CLARIFICATION No:1
to the
TENDER DOSSIER
Supply of Vaccines and Vaccine Transport Vehicles
Publication Reference: SIHHAT/2017/SUP/INT/01/BIS
Location –Europe (non EU/Turkey)

The following clarification is made to the tender dossier

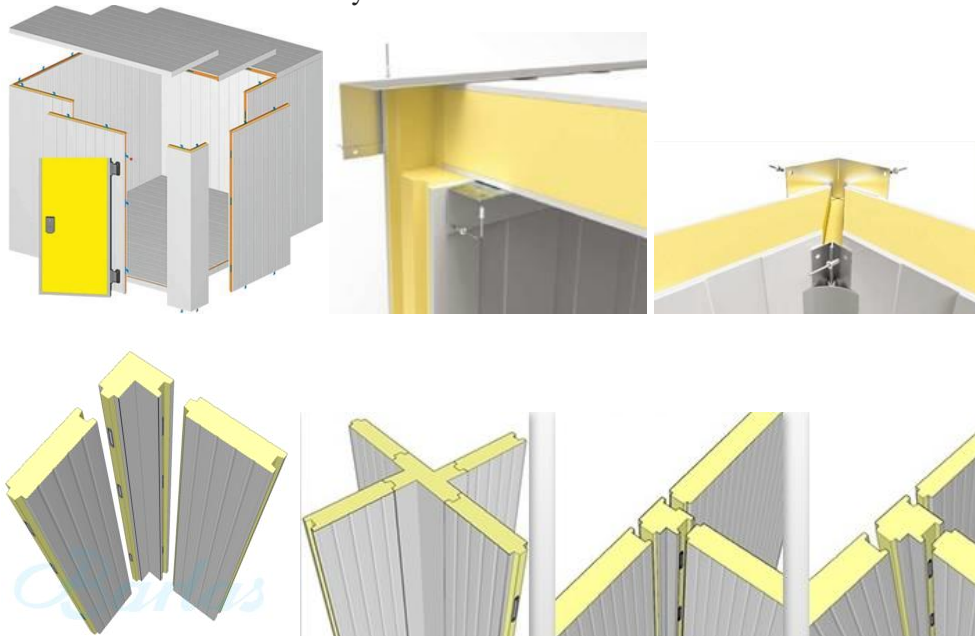
Answer 19:	Please see Answer 11.
Lot 9	
Question 20:	<p>Regarding to Lot 9;</p> <p>For Cooling Units; about some substances to be added In addition to the materials specified in the technical specification, we consider that writing the following substances will increase the usability, useful life and quality of the product to</p>

be purchased. For this reason, we want to inform you about the advantages and disadvantages of why these materials should be used.

1. Isolation of the body of the device should be "Monoblock" construction.

Because;

It is known that coolers are produced with 2 types of body structure. One of them is the systems which are combined with bolts or other fasteners from edges and corners with collecting part structure with old production technology. These systems are called bodied structures with collective parts. Their service life is short and their thermal insulation is low. In this project, if it is described for the purpose of use, it will loosen at the connection points over time and cause leakage, so that the residence and vibration will be constantly exposed in the vehicle. In such a case, the useful life of the device will be shortened and its performance will be significantly reduced. The best example of this is the cold air chambers. Before the construction of these rooms, careful handling of the points can cause serious problems in the cold weather and make it impossible to use. For this reason, the area where the scene is never moving can not be made cold room with vibrations, because it is known that there will be time to open at the connection points.

As the surfaces of devices such as this device will be constantly in contact with the outside environment, expansion and contraction due to cold-hot differences will create a force on this surface, which will cause surface stresses at joints and joints, and these stresses should be opened or separated at connection points. The following illustrations present the best illustration of the trunked body structure.

The monobloc body structure is the new technology production and it is a necessary body structure for low electricity consumption and heat conservation in cooling or heating devices due to the fact that our country has entered the tropical climate in recent years. This structure is generally referred to as a unitary or single-body structure. Since there is no gap or additional connection points between the inner surface and the exterior, it provides a seal that provides full insulation and extends the useful life significantly. This is the state of the art technology for all portable devices with built-in insulation and isolation. All devices are manufactured in this way from household refrigerators to deep freezers to thermosiphons to hot water storage rooms where heat insulation is required. In addition this device will not be affected by vibrations that occur due to road conditions when the device is mobile and considered to be used in moving vehicles (since the device has a monolithic structure and therefore there are no connecting elements or pieces on the edges or the corners). Below, some device with single body structure has been presented with visuals.

Answer 20: Please see Changes No:2 to Tender Dossier
